SERVICE BULLETIN SB00.01

Machines/Models: LX31/41/50 4WD **Serial Numbers:** 1000 to 3103

PURPOSE: To assure correct positioning of Axle Float Cylinder Fitting Adapters.

Figure 1: Front of machine

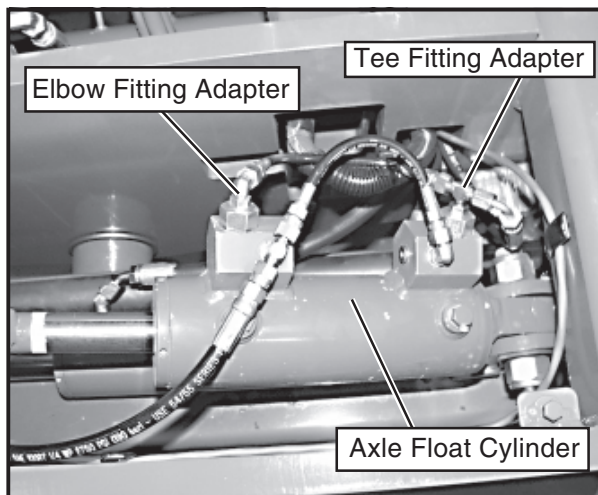
1. Platform must be in stowed position and machine on firm level surface.
2. Remove cover on front of chassis exposing Axle Float Cylinder. See Figure 1.
3. Locate Tee Fitting Adapter and Elbow Fitting Adapter. See Figure 2.
4. Verify clearance between Jam Nut and Fitting Adapter is 3/32"(2.38mm) to 1/8"(3.17mm). See Figures 3 and 4.

Figure 3

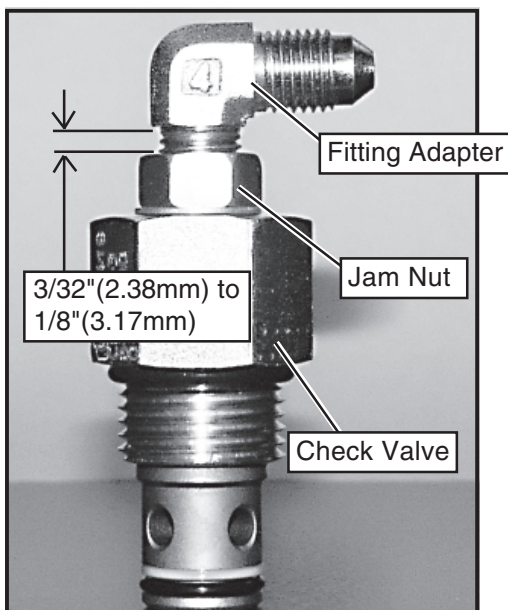
NOTE: If clearance between Jam Nut and Fitting Adapter is within the range of 3/32"(2.38mm) to 1/8"(3.17mm), proceed to item #10. If clearance is not within that range, proceed to item #5.

5. Remove pilot hoses from Tee Fitting Adapter and Elbow Fitting Adapter. See Figures 3 and 4.
6. Loosen Jam Nuts on Fitting Adapters and turn Fitting Adapters until the clearance between Jam Nuts and Fitting Adapters is between 3/32"(2.38mm) to 1/8"(3.17mm). See Figures 3 and 4. **NOTE: Cylinder may have two Tee Fitting Adapters or one Tee and one Elbow Fitting Adapter.**

7. Tighten Jam Nuts on Fitting Adapters and torque to 10-12 in. lbs. (1.12-1.35 Nm).
NOTE: Verify clearance between Jam Nuts and Fitting Adapters remains at 3/32"(2.38mm) to 1/8"(3.17mm).
